# **HARVEY WATER WATER CORPORATION**

## **Review of Dam Safety Program Relating to South West Irrigation Dams**

**Final Report : August 2003**

**Figure 4.1 : Schematic illustration of the seasonality of some flood modifying factors**

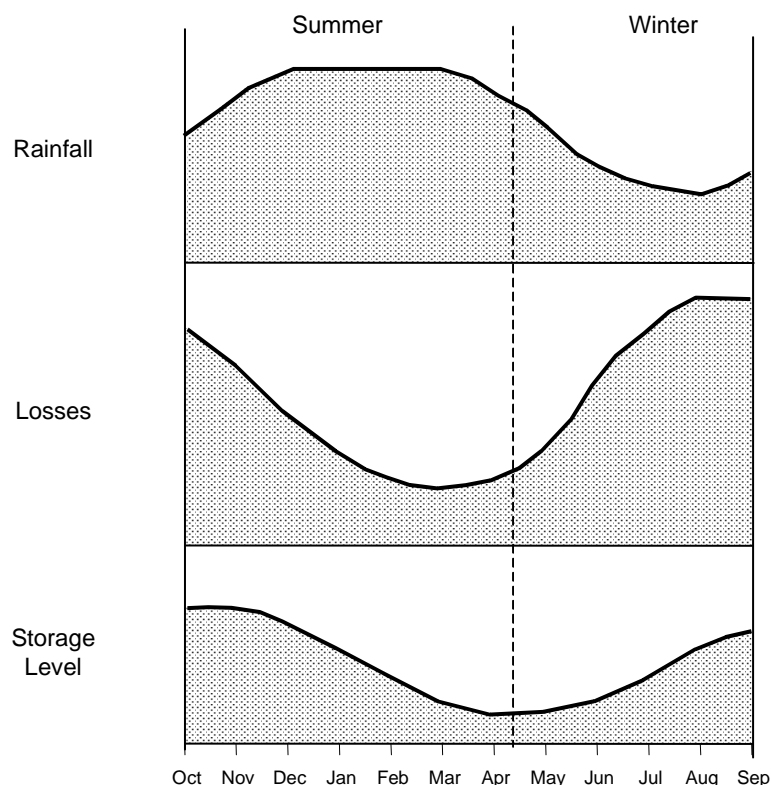
At present the analyses are based on dividing the year into two seasons (Oct-Apr, May-Sep). However, as illustrated in Figure 4.1, it appears reasonably possible that if only two seasons are selected then unlikely combinations of factors may result. For example, with the specified seasonality, high rainfalls could occur with either high or low losses, and in terms of outflows, these may coincide with either low or high initial reservoir conditions.

Preliminary analyses indicate that consideration of four seasons rather than two may be more appropriate (the occurrence of rainfall maxima is divided into summer and winter, and other inputs are divided into four seasons, namely Oct-Dec, Jan-Apr, May-Jun, Jul-Sep). Exploratory investigation indicates that (if the model is adequately calibrated) there will perhaps be little difference in the magnitude of the inflow flood, but there may be an increase in the likelihood of overtopping due to the seasonal distribution of storage level.

**Figure 4.4 : Waroona Dam Comparison of F-N Curve to ANCOLD Societal Risk Criteria**

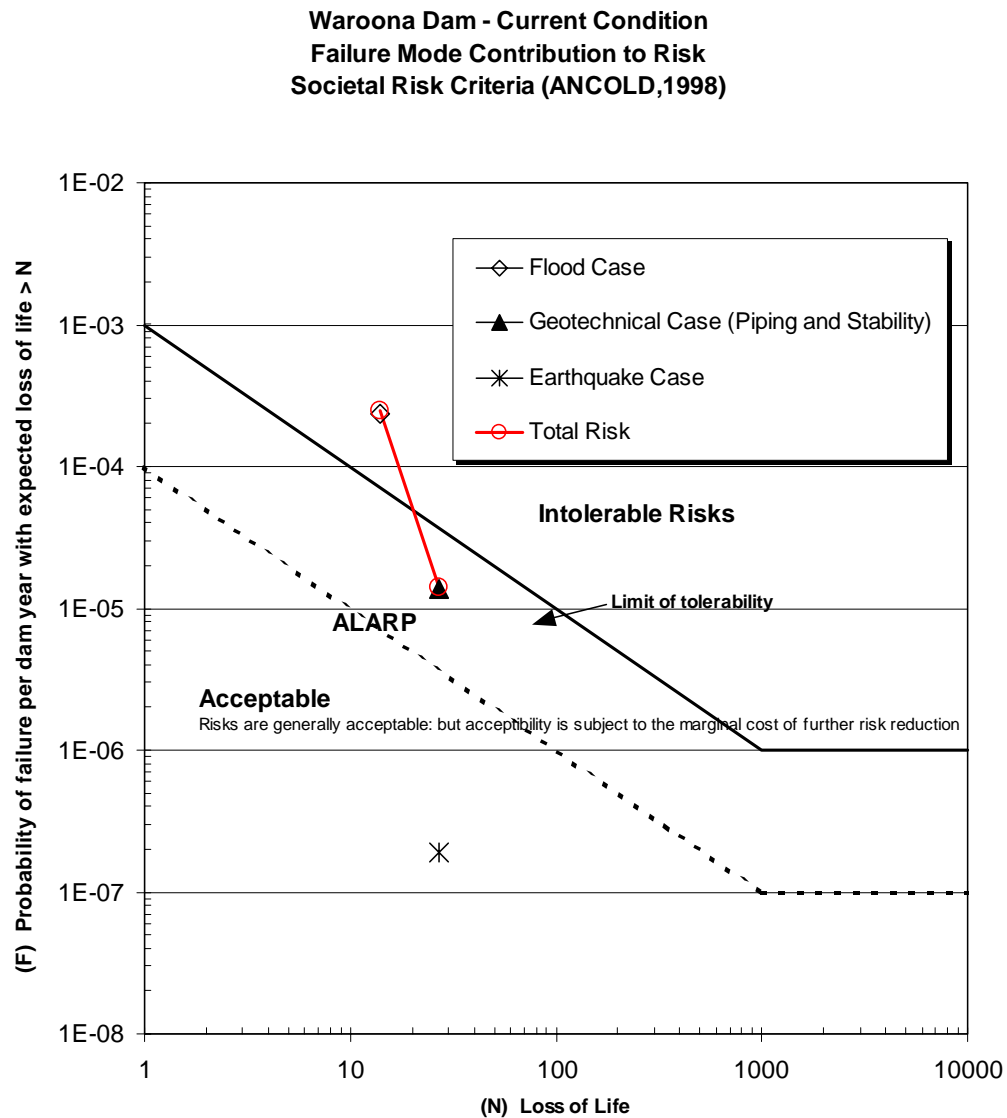
Figure 4.4 shows the component f-N and total F-N curves plotted against the ANCOLD societal risk criteria. The event trees are provided in Appendix A. The annual probability of piping failure under normal operating conditions estimated using the event tree method is approximately an order of magnitude lower ( $1.2 \times 10^{-5}$  per annum) than estimated by Geo-Eng using the historic performance statistics ( $1 \times 10^{-4}$  per annum). The portion of the F-N curve contributed from foundation piping falls within the ALARP region.

Figure 4.9 Waroona Dam, Current Study Stability Analysis (Using Geo-Eng Foundation Shear Strength Parameters)

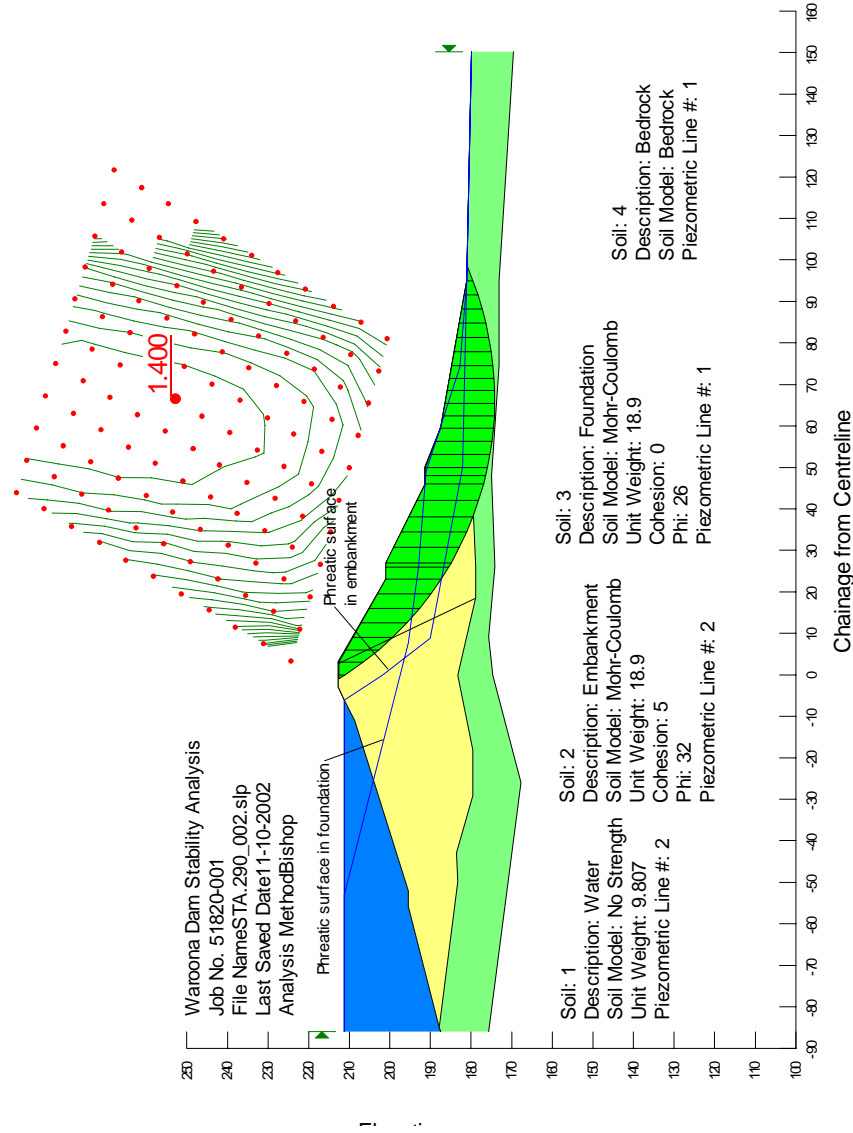
The construction of the proposed downstream berm provides downstream weighting and increases stability even with elevated pressures, and in essence provides another level of defensive design to the upgraded foundation seepage collection system and upstream blanket. The downstream berm also provides a means for raising the dam to achieve the required flood capacity and providing a modern downstream filter. According to Bob Wark, it was essential that the design provide reliable stability even if one element of the design did not function as intended.

**Figure 4.12 : Wellington Dam Section**

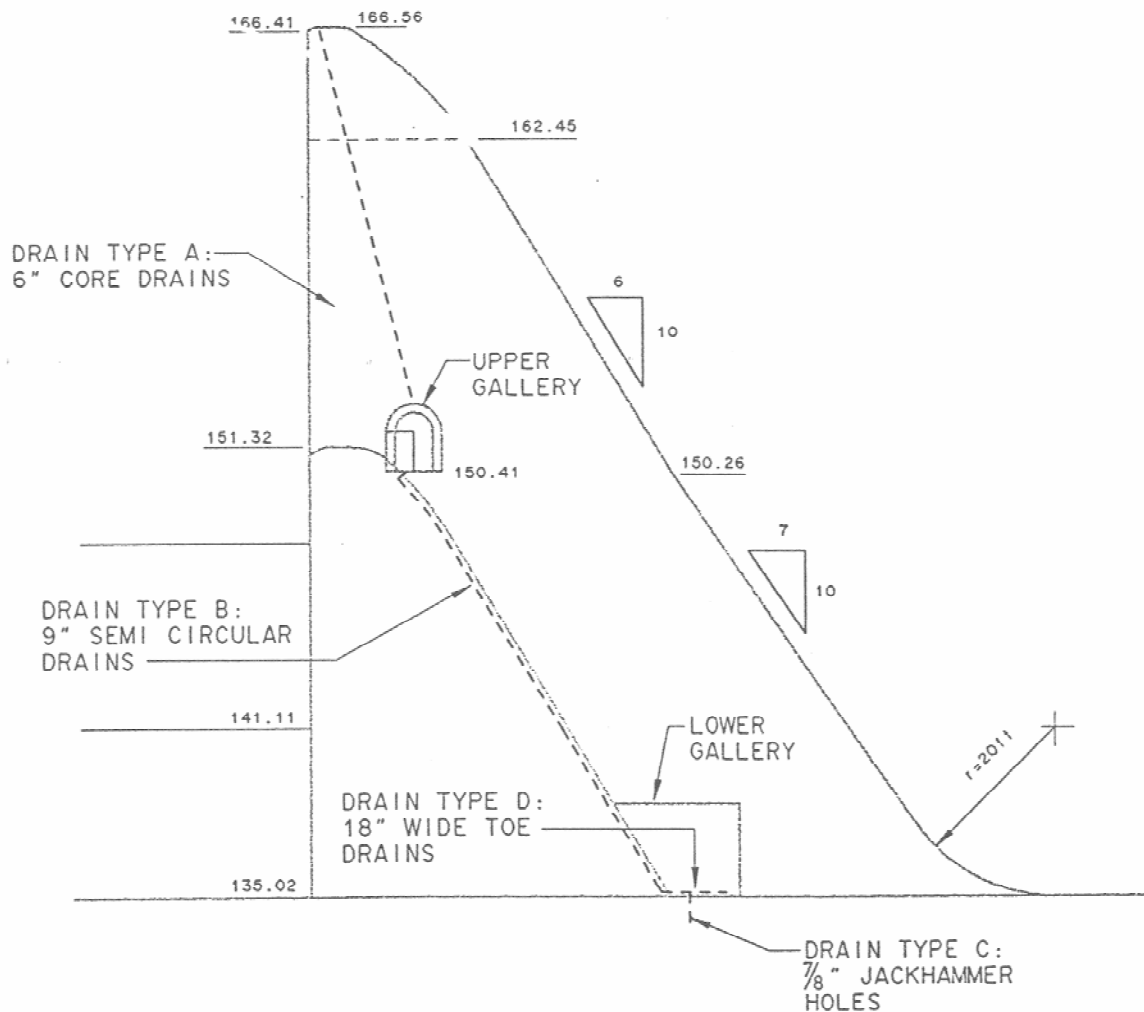
The static stability of Wellington Dam shown in Plate 4.8 and Figure 4.12 has been assessed by Geo-Eng and is reported in the report "Wellington Dam Safety Review" dated February 2002. The methodology and assumptions adopted in the stability analysis appear reasonable and are based on sound engineering principles. The significant finding of that study is that the stability of the dam would be marginal under a flood loading with an AEP of approximately 1 in 1,000. Furthermore, the estimated loss of life in a sunny day failure would be 550 and in a flood, 175, making Wellington an extreme hazard dam.

There are several concerns with the stability of the dam:

- cracking through the original dam;
- disadvantageous joint orientation in the foundation rock (Plate 4.9);
- cracking at the base of the original dam (Plate 4.10); and
- AAR raising and rotating the crest upstream (Plate 4.11).

We endorse Geo-Eng's recommendations for reducing the risk in the short term, which include drain cleaning, increased instrumentation and increased frequency of measurements. However, given the relatively high risk of failure of the dam under flood conditions even after the drains are cleaned, consideration should be given to the implementation of additional measures to further reduce the risk in the short term such as those recommended by Water Corporation's reviewer, Graeme Bell. These are reported in his notes prepared after the 30 May 2000 briefing and, as well as drain cleaning, include:

- developing a preliminary emergency preparedness plan with some early warning systems defined;
- deepening the existing foundation drainage curtain; and
- lowering the present operating FSL.

**FIGURE A-2 SCHEMATIC ILLUSTRATION OF THE SEASONALITY OF FLOOD MODIFYING FACTORS**

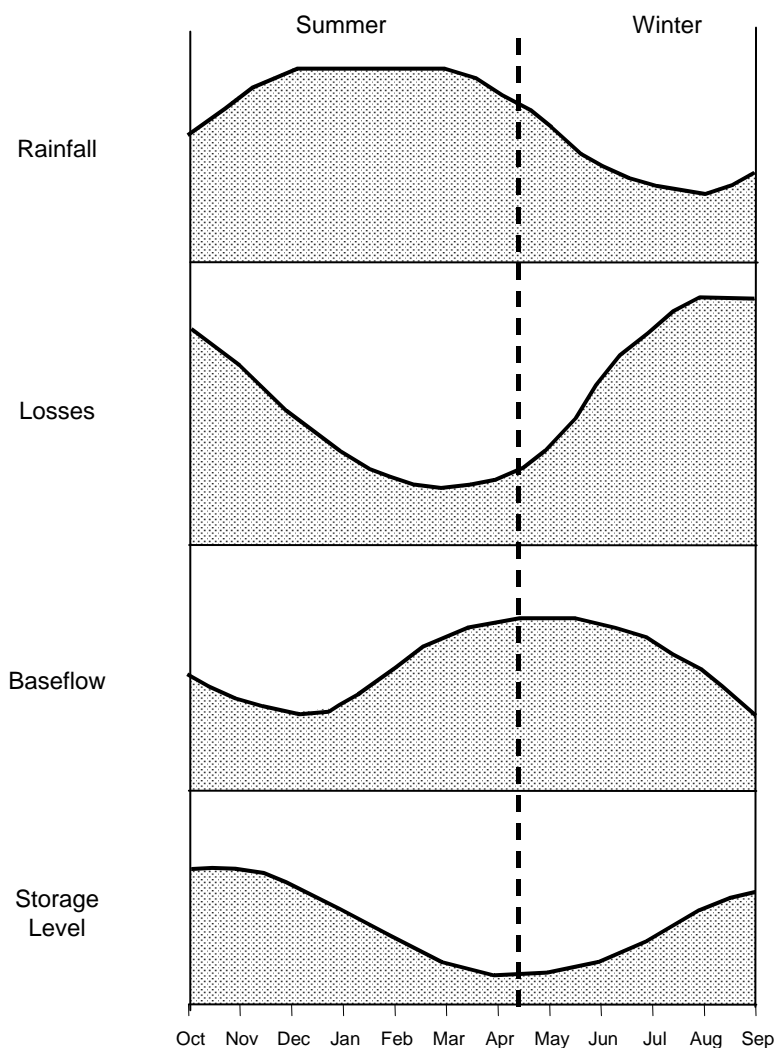
The hydrology studies have all been analysed assuming two seasons (indicated as “summer” and “winter” in Figure A-2). This involves the assumption that specific combinations of these factors are likely to occur together, or at least that the selected combination is typical of the range of combinations that are likely to occur within each specified season. Given the significant variation of the factors between flood events, it is often necessary in practice to focus the analysis on some dominant combinations and

neglect those combinations that are unlikely to contribute significantly to the total flood probability. However, as illustrated in Figure A-2, it appears reasonably possible that if only two seasons are selected then unlikely combinations of factors may result. For example, with the specified seasonality, high rainfalls could occur with either high or low losses, and in terms of outflows, these may coincide with either low or high initial reservoir conditions.

In order to better represent these seasonal factors by representative average (or distributional) values, it may be more appropriate to divide the year into four seasons. The likelihood of rainfall depths of a given magnitude may be differentiated across only two seasons, but the other factors could be varied as deemed appropriate.

**FIGURE A-3 IMPACT OF UNDERTAKING ANALYSES BASED ON FOUR RATHER THAN TWO SEASONS (LOSSES, INITIAL STORAGE LEVEL, AND TEMPORAL PATTERNS ARE STOCHASTICALLY SAMPLED).**

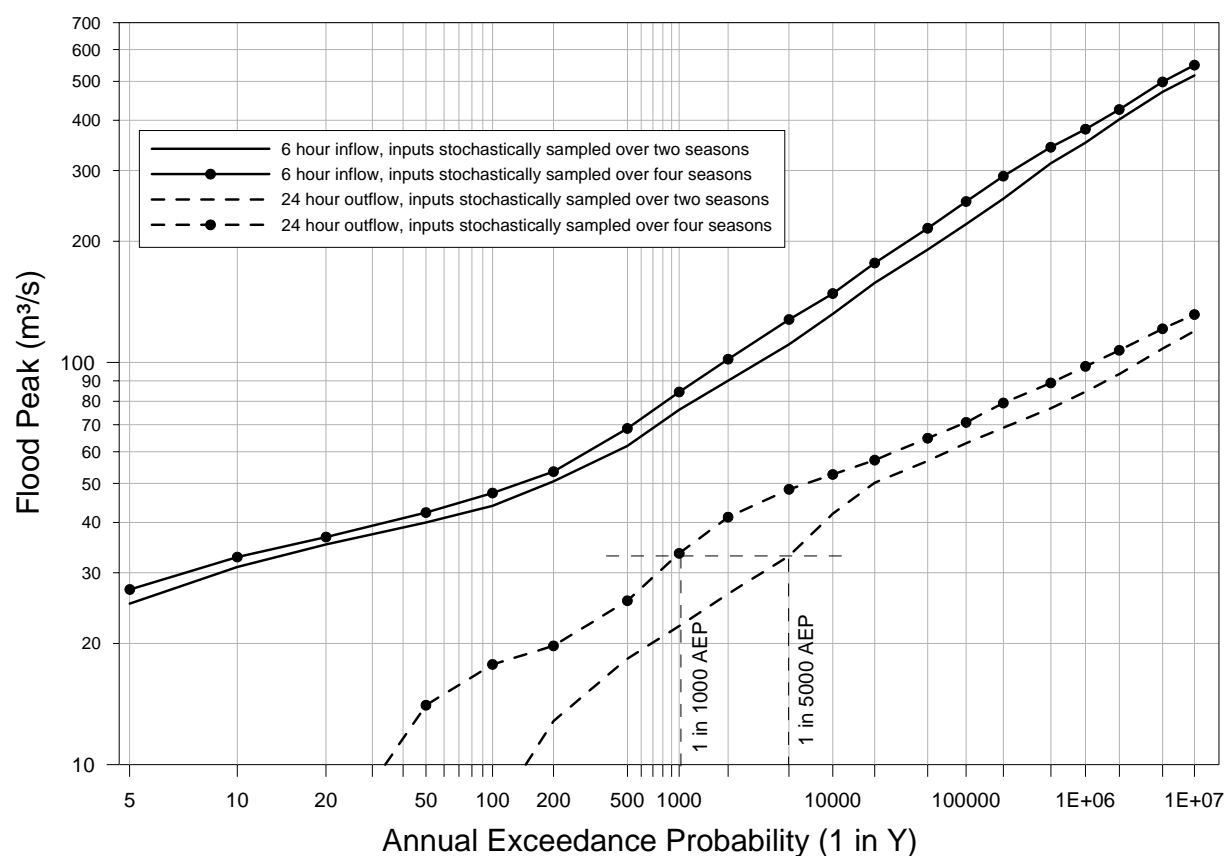
Section A.4. The simulations were based on the Logue Brook catchment, though the results should be viewed as being notionally indicative of the sensitivity to seasonality as the version of loss model used has not been calibrated. Results were obtained for the 6-hour event for inflows, and a 24-hour event for outflows, and the results are summarised in Figure A-3.

If the inflow design floods are adequately calibrated (ie it is assumed that the both methods are calibrated to yield the same estimate of, say, the 1 in 100 AEP event), then incorporation of four seasons for losses will have little influence on the magnitude of the inflow floods. This is because the slope of both curves are the same, and they will be anchored at the same point. Accordingly, the increase in overtopping likelihood by sampling from four seasons will perhaps be less (say between a three- to four-fold increase).

**FIGURE A-8 IMPACT OF TAKING INTO ACCOUNT THE DISTRIBUTION OF INITIAL LOSS PARAMETERS COMPARED TO FIXED SEASONAL VALUES (TWO SEASONS ARE BASED ON OCT-APR AND APR-SEP, AND FOUR SEASONS ARE BASED ON MAY-JUN, JUL-SEP, OCT-DEC, AND JAN-APR).**

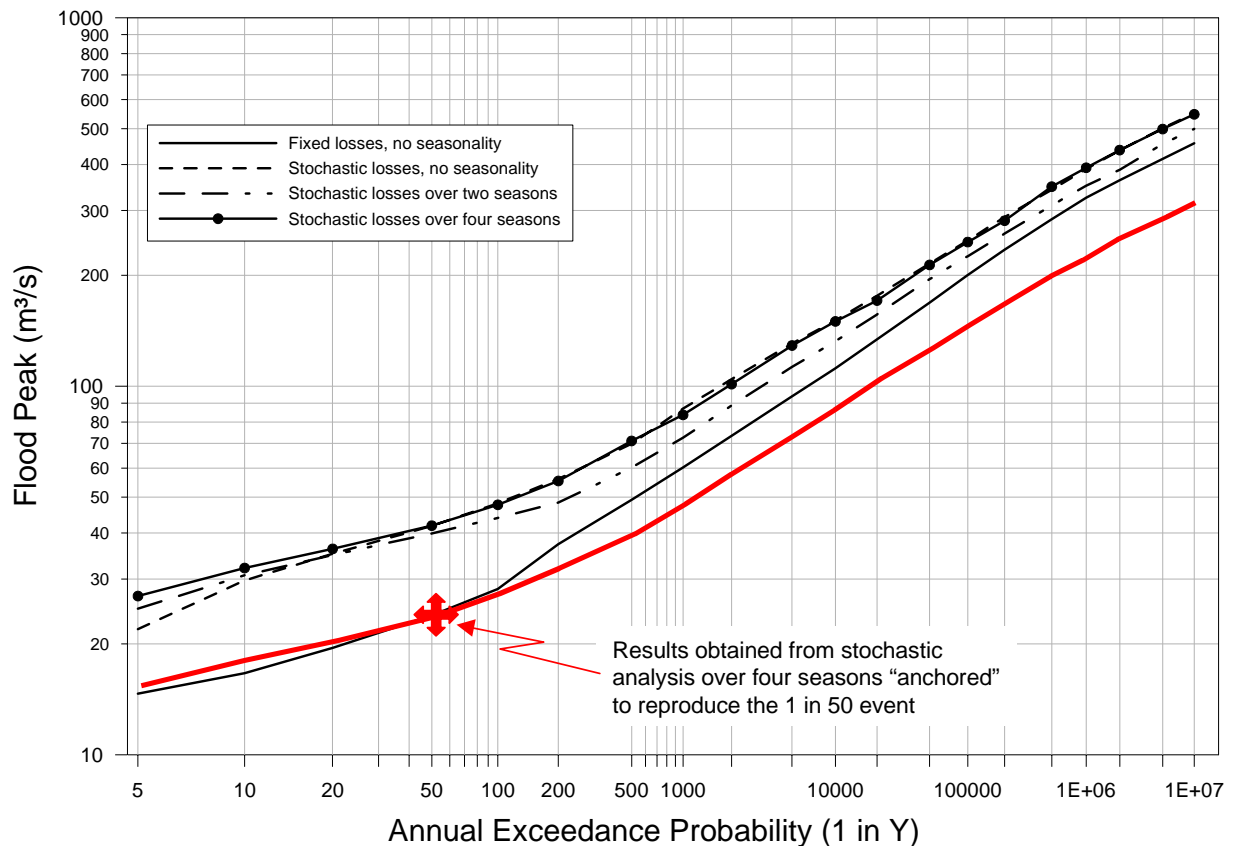
The sensitivity of the results to adoption of a fixed versus a seasonal distribution of initial soil moisture conditions is shown in Figure A-8. The results were obtained using Monte-Carlo simulation techniques, in which the initial soil moisture was sampled from the different distributions. For consistency, the results for the fixed initial soil moisture conditions were obtained by adopting the median soil moisture level derived from the different distributions. A simplified version of SWMOD was incorporated into the Monte-Carlo framework, in which only one soil type was represented and the gross rainfall was assumed to be spatially uniform across the catchment (the Dwellingup soil parameters were used where  $C_{max}$ ,  $C_{min}$ , and  $b$  were set to 1440, 96, and 2.25, respectively).

events. If it is assumed that the model is calibrated correctly (thus the estimates of, say, the 1 in 50 AEP event are the same for both approaches) then it is evident that adoption of a distribution of values yields *lower* extreme flood estimates than the current approach. This is illustrated by the thick red (annotated) line in Figure A-8. The difference increases as the magnitude of the event increases; for example for inflow events around the 1 in 5000 AEP event the distributional approach would yield results around 25% lower, for the PMPDF the results would be around 35% lower.

**FIGURE A-11 SPECULATIVE RESULTS OBTAINED FOR CASE IN WHICH SEASONAL  
DRAWDOWN IS ALLOWED.**

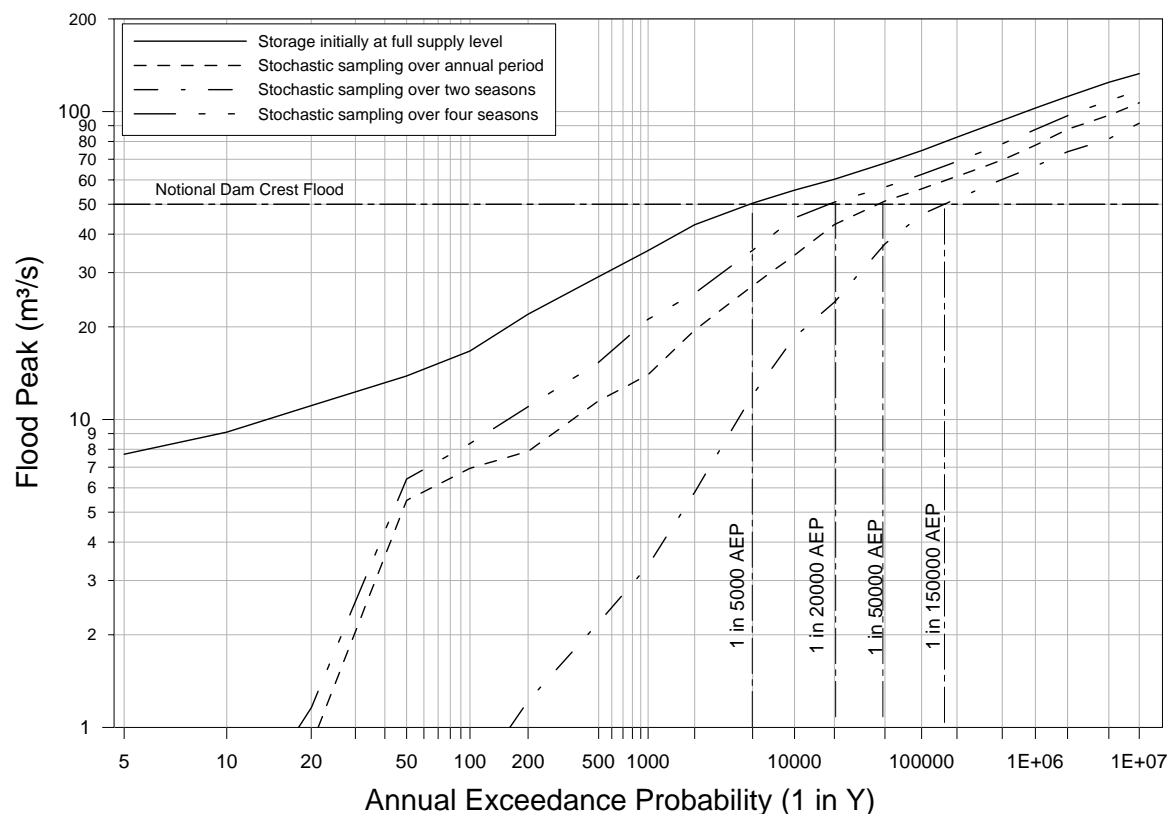
The results obtained allowing for drawdown are illustrated in Figure A-11. While the results are based on design rainfalls and historic reservoir conditions relevant to Logue Brook, the results are obtained using loss model parameters that are not calibrated to the catchment. In addition, the results shown are for a 24 hour event and it may be that another duration is more critical. To provide a useful benchmark for comparison a notional Dam Crest Flood has been selected that has around a 1:5000 AEP of being exceeded, a likelihood that has been estimated by the Water Corporation to represent the current hydrologic risks of overtopping for Logue Brook.

It is clear from this analysis that the consideration of drawdown may have a large influence on the estimated likelihood of overtopping failure. Depending on the assumption used of initial storage condition (and seasonality of distribution) the AEP of overtopping is seen to vary between 1 in 5000 AEP down to 1 in 150000 AEP. The results indicate that the joint probability analysis based on two seasons would severely underestimate the outflow flood frequencies.
